MORGAN AND MORECAMBE OFFSHORE WIND FARMS: TRANSMISSION ASSETS

Errata

Deadline: Deadline 2
Application Reference: EN020028

Document Reference: S_D1_14/F02
Rev: F02

A.1 MCZ Assessment – Figure 1.7

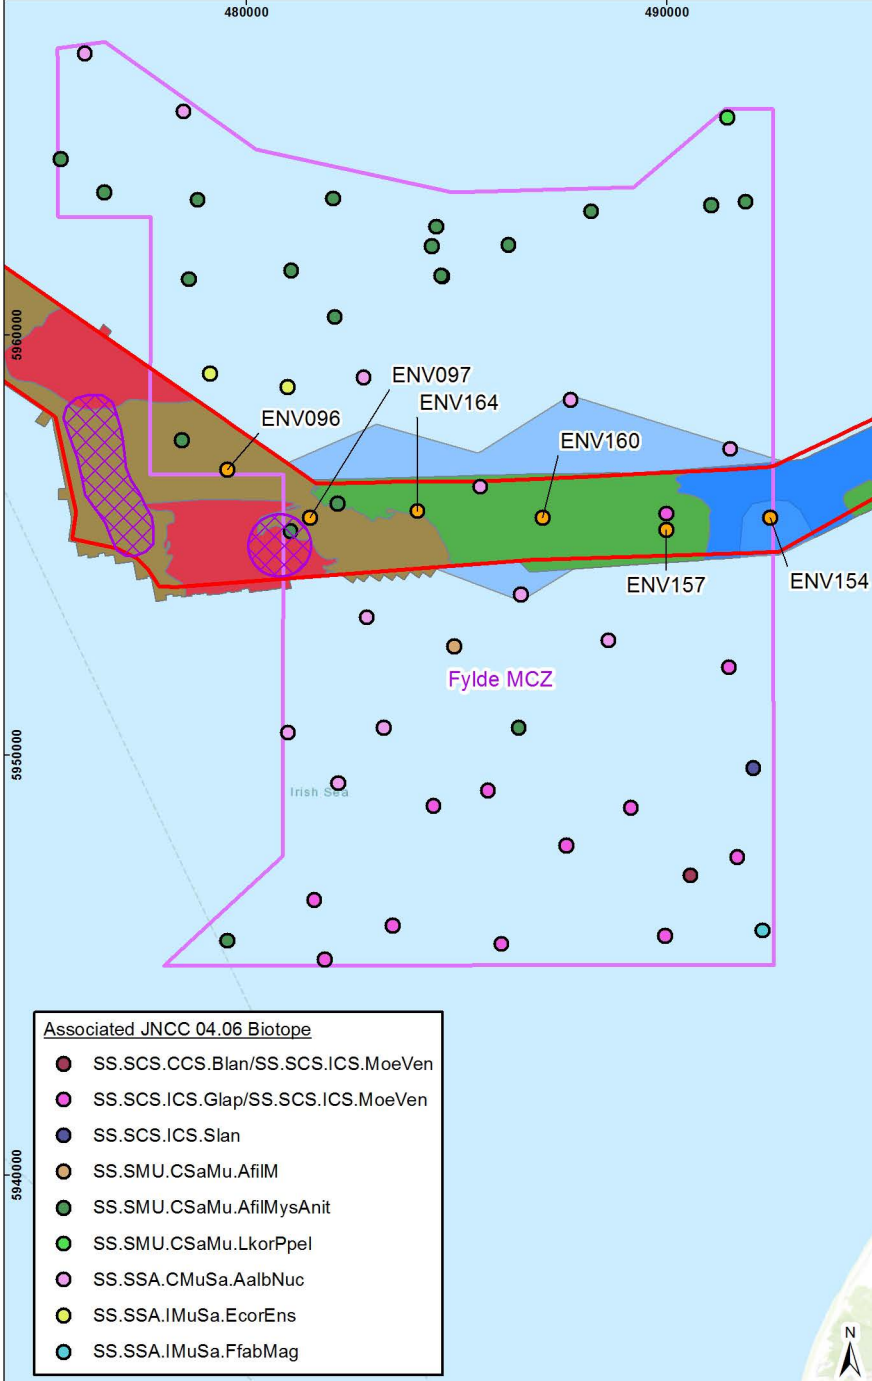
Errata document version	Document section	Description of errata
F01	Figure 1.7	The Applicants can confirm that the potential 'seapen and burrowing megafauna communities' IEF mapped in Figure 1.22 of Volume 2, Annex 2.1: Benthic subtidal and intertidal ecology technical report (APP-046) was erroneously missed from Figure 1.7 of the MCZ Screening and Stage 1 Assessment Report (APP-019). Figure 1.7 has been updated for Examination at Deadline 2 (see Appendix A).
F01	Table 1.6	The Maximum design parameter for the Maximum total volume of cable protection (m ³), within MCZ (shown in the last row of the table) should be 30,400.
